SOILS REPORT APPROVAL LETTER

TRACT: IRVING PARK (M B 17-18/19)
LOT(S): 11 / 12 / 13 / 14
LOCATION: 5600-5606 W Hollywood Blvd, 1655-1681 N St. Andrews Pl, 5607 W Carlton Way

<u>CURRENT REFERENCE</u> <u>REPORT/LETTER(S)</u>	<u>REPORT</u> <u>No.</u>	<u>DATE OF</u> <u>DOCUMENT</u>	<u>PREPARED BY</u>
Soils Report	700071901	10/05/2020	Langan Engineering and Environmental Services, Inc.
Laboratory Testing Report	2012-0057	04/30/2020	Geo-Logic Associates
Geophysical Data Report	20241-01 rev0	08/10/2020	GEOVision Geophysical Services

The Grading Division of the Department of Building and Safety has reviewed the referenced report that provides recommendations for the proposed tiered residential tower over 2 to 3 subterranean parking levels.

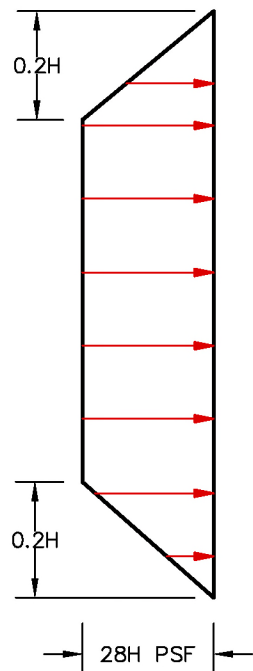
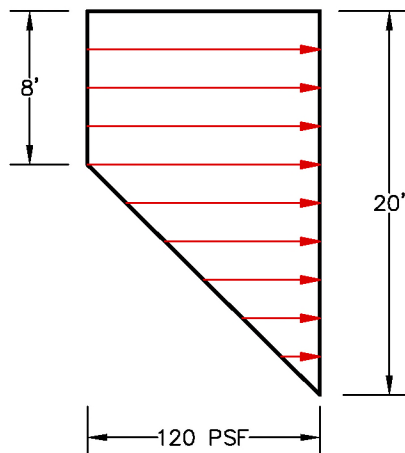
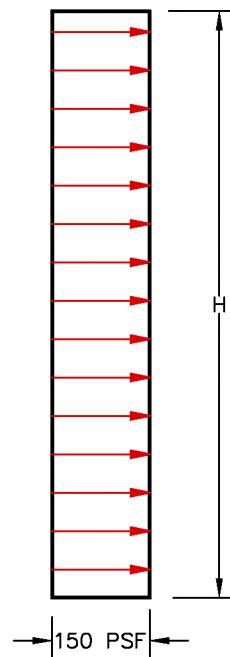
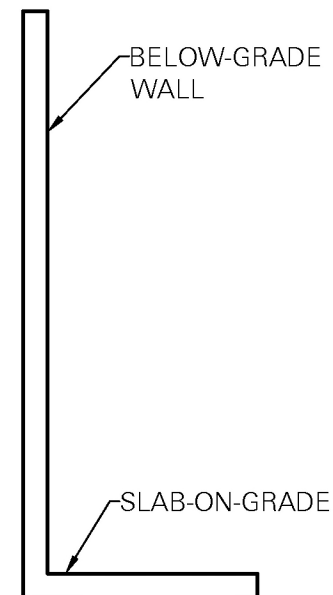
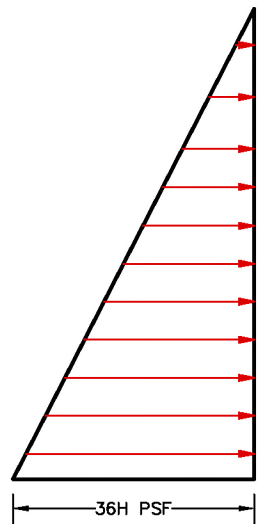
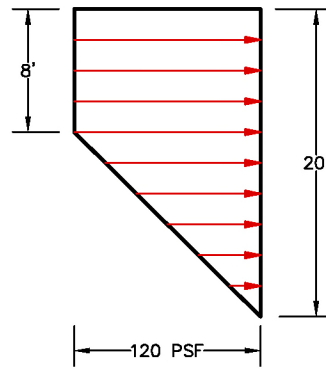
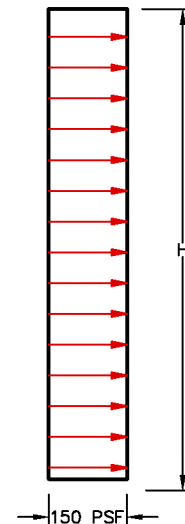
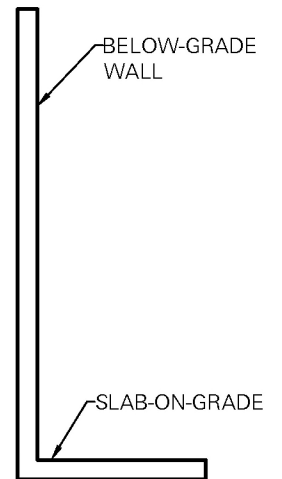
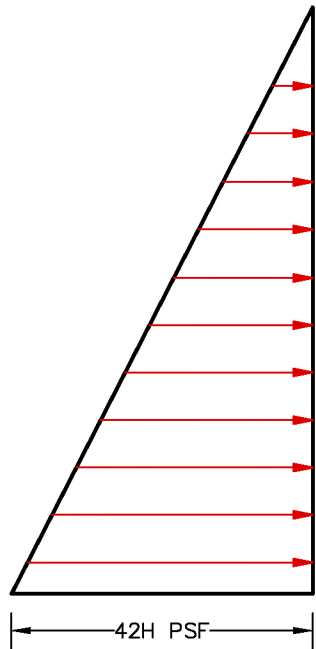
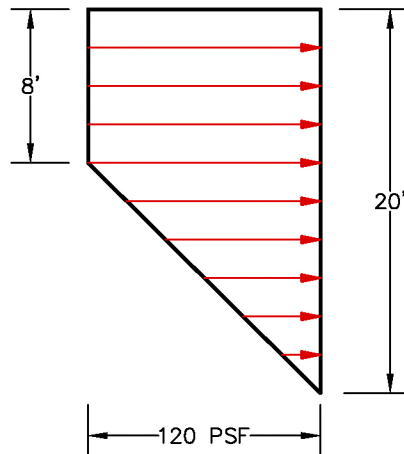
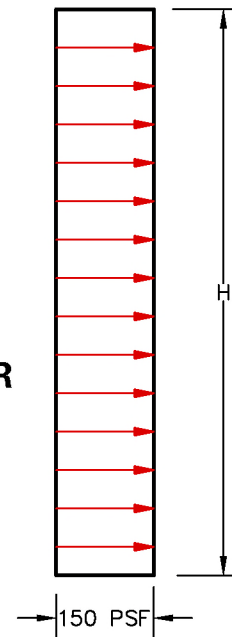
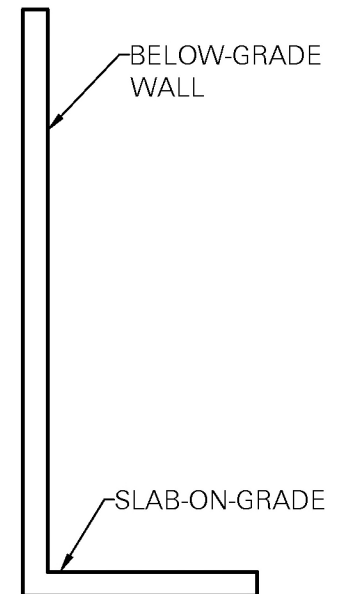
23. Retaining walls shall be designed for the lateral earth pressures specified in the section titled "Design Lateral Earth Pressure" starting on page 10 of the 10/05/2020 report. All surcharge loads shall be included into the design as shown on Plates 9 and 10.
